Responses to Blackwell Submission of 18 July 2016 (submitted 25 July 2016)

Image 1. Northern Profile indicating comparative window and floor levels.

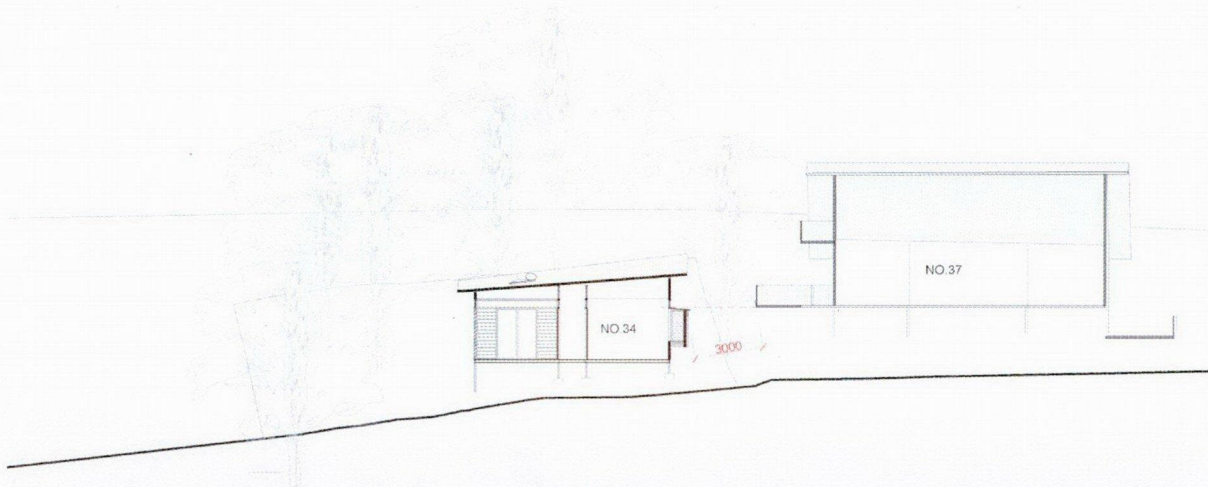
- A. **Image #1**(below) illustrates that both floor and window levels of the dwelling proposed for 34 Coasters Retreat sit substantially **below** those of the existing dwelling located on 37 Coasters Retreat.

- C. Comments made about the apparent proximity of the proposed dwelling, and that projects “even closer” to “...*the most constantly and heavily used living and entertaining areas and decks (north facing) at no. 37 [sic]*”, are noted. The comments **cannot be sustained when examined against actual measurements for the proposed dwelling and proposed separation points.** Please refer to measurements **Images #1 and #2** (below and overleaf) as well as detailed site location plans included in this submission.

Image 2. Overlay Profile indicating actual separation of proposed dwelling from existing dwelling on 37 Coasters Retreat and acoustic isolation factors.

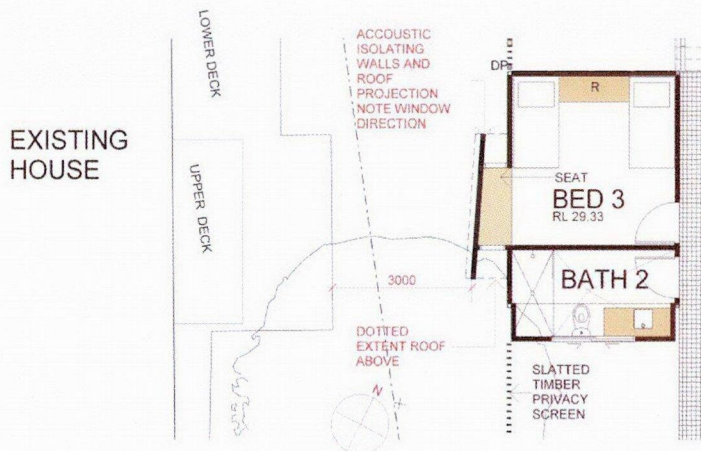
- B. In addition, it is noted that some comments rely on incorrect measurements of proposed dimensions and separation points (i.e. references to "...the proposed dwelling being located approximately 2.5 metres from principal living and entertaining rooms and private open space..."). Again, please refer to **Image #1.** and **Image #2.** preceding.
